Access Compliance Report

Public Rights-of-Way

(Curb Ramps)

Intersection ID: 27841	Main Street: BALLANTYNE COUNTRY CLUB DR	Cross Street: OLD WAYSIDE RD	Location: NE
ADA ID: B1E02C6A5CBB	Ramp Type: Perp	Initial Pass/Fail: Fail	Overall Compliance: No
Severity Score: 21.25			
Codes/Mitigation Info/Possible Solution		Field Measurements/Component Compliance

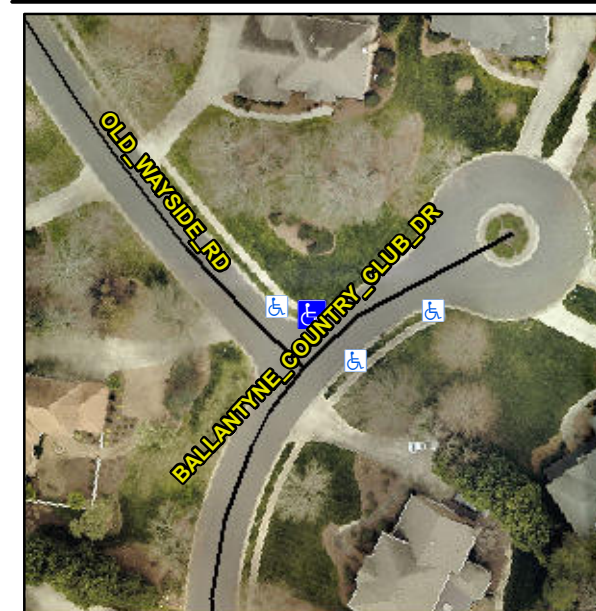
Not Found, R304.5.1, R304.5.3

Compliance	Description	Data	Compliance	Description	Data
N/A	Ramp Length (in)	48.0	Yes	Ramp Slope (%)	7.6
No	Ramp Width (in)	41.0	No	Ramp XSlope (%)	6.5
N/A	Flare Type LT	N/A	N/A	Flare Type RT	N/A
N/A	Flare Slope LT (%)	N/A	N/A	Flare Slope RT (%)	N/A
N/A	Flare Traversable LT?	N/A	N/A	Flare Traversable RT?	N/A
N/A	Landing Length (in)	N/A	N/A	DWS Provided?	N/A
N/A	Landing Width (in)	N/A	N/A	DWS Contrast?	N/A
N/A	Landing Slope (%)	N/A	N/A	DWS Length (in)	N/A
N/A	Landing X Slope (%)	N/A	N/A	DWS Full Width?	N/A
N/A	Landing Curb? (Y/N)	N/A	N/A	DWS Offset (in)	N/A
N/A	Shared Landing?	N/A			
N/A	Gutter Ponding?	N/A	N/A	Gutter Slope (%)	N/A
N/A	Gutter Lip Ht (in)	N/A	N/A	Gutter X Slope (%)	N/A
N/A	Painted X Walk1?	No	N/A	Painted X Walk2?	N/A
	X Walk 1 Direction	To SE		X Walk 2 Direction	N/A
N/A	X Walk 1 Width (in)	N/A	N/A	X Walk 2 Width (in)	N/A
	X Walk 1 Slope (%)	0.3		X Walk 2 Slope (%)	N/A
	X Walk 1 X Slope (%)	3.8		X Walk 2 X Slope (%)	N/A

Remove & Replace Entire Ramp.
